APRIL 26, 2021

SUBJECT: **INITIAL COMMENTS LETTER**
PROJECT NAME: COPPERLEAF SUBDIVISION
PROJECT #2006060037
APPLICATION: PRELIMINARY PLAT #26132

COPPERLEAF SUBDIVISION
MARION COUNTY, FL
PRELIMINARY PLAT
MASTER SITE PLAN

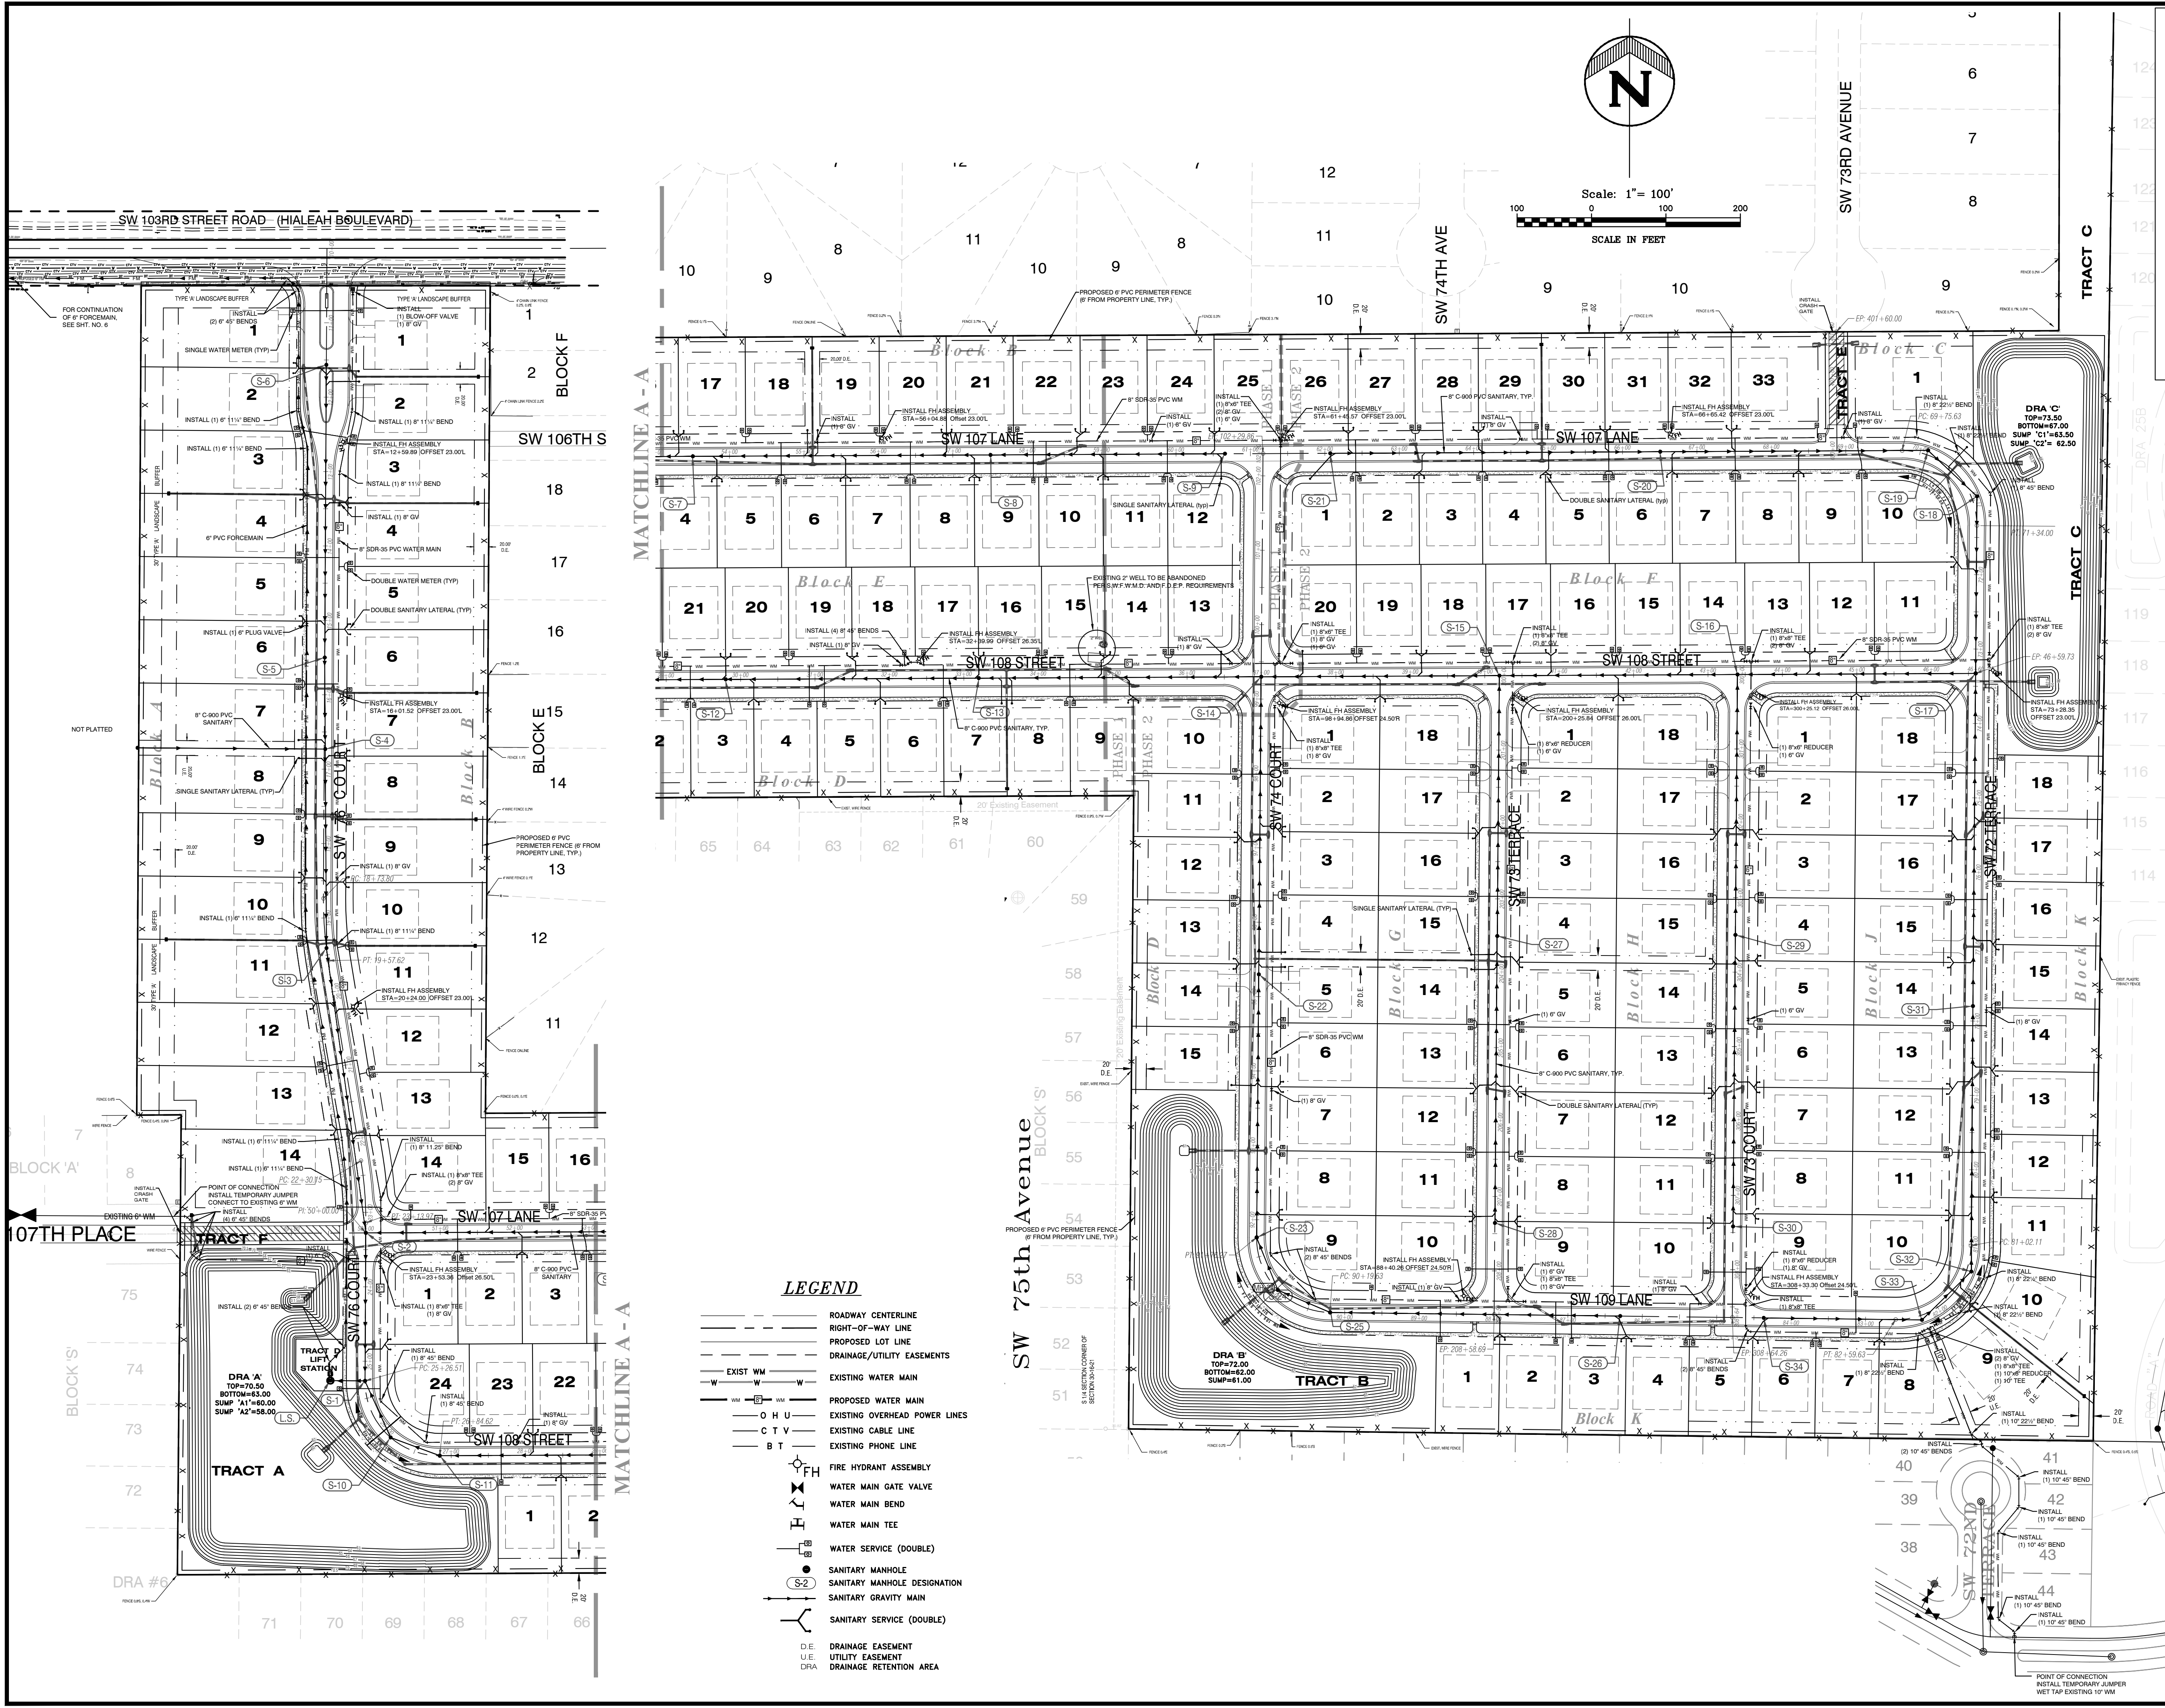
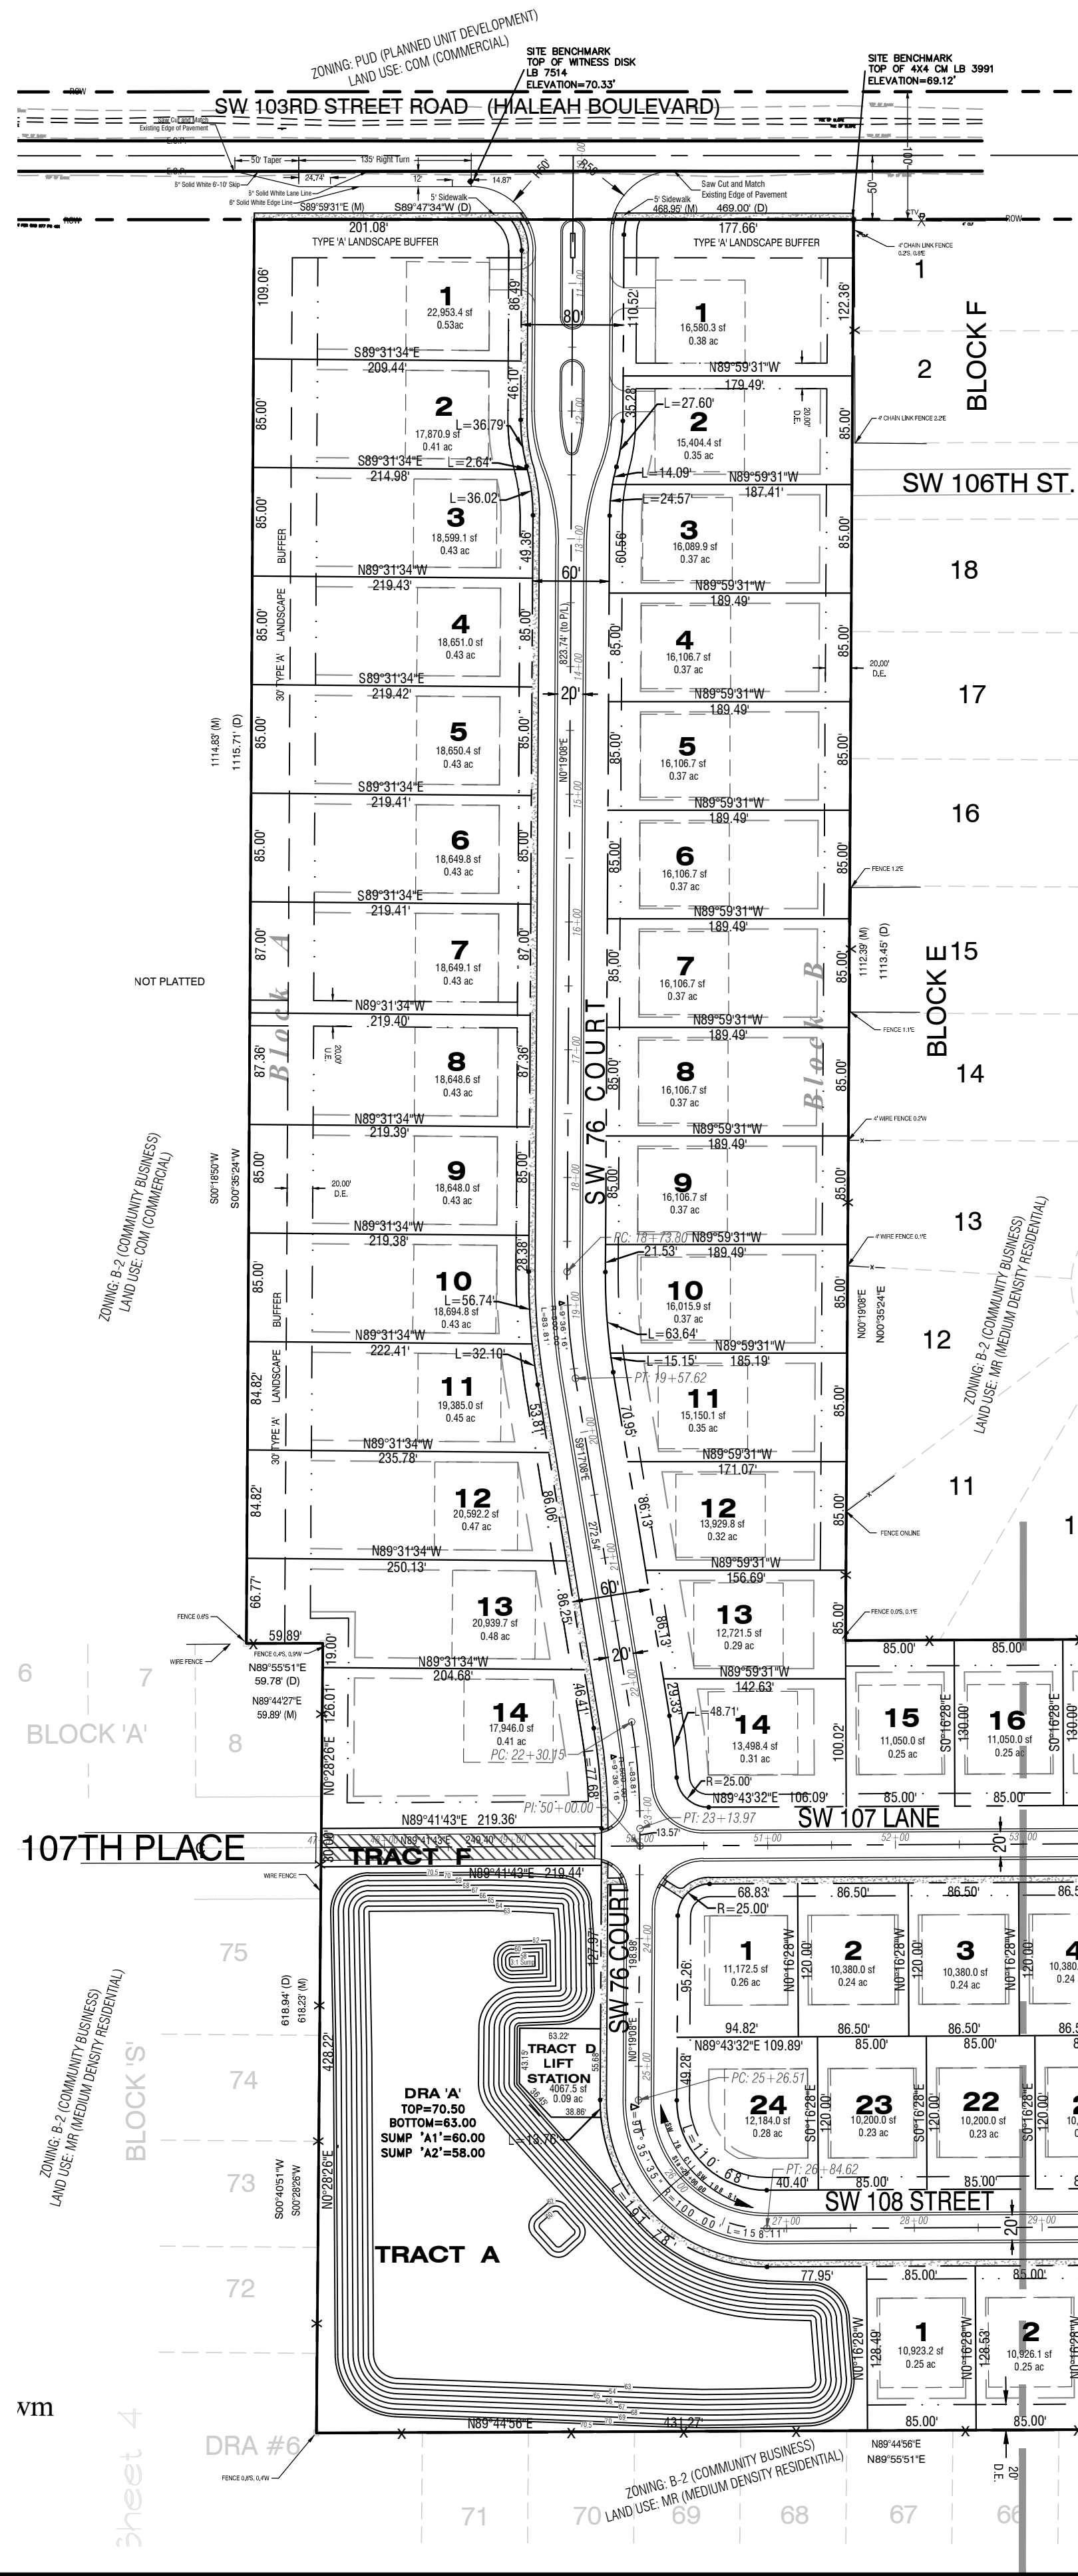
7. DEPARTMENT: ENGIN - DEVELOPMENT REVIEW
REVIEW ITEM: 2.14.1.B - Preliminary Plats that show the phasing for a development project can be used in lieu of a Master Plan
STATUS OF REVIEW: ENGINEER ACKNOWLEDGED INFO COMMENT
REMARKS: 4/20/21 - 2 phases shown on sheet 4
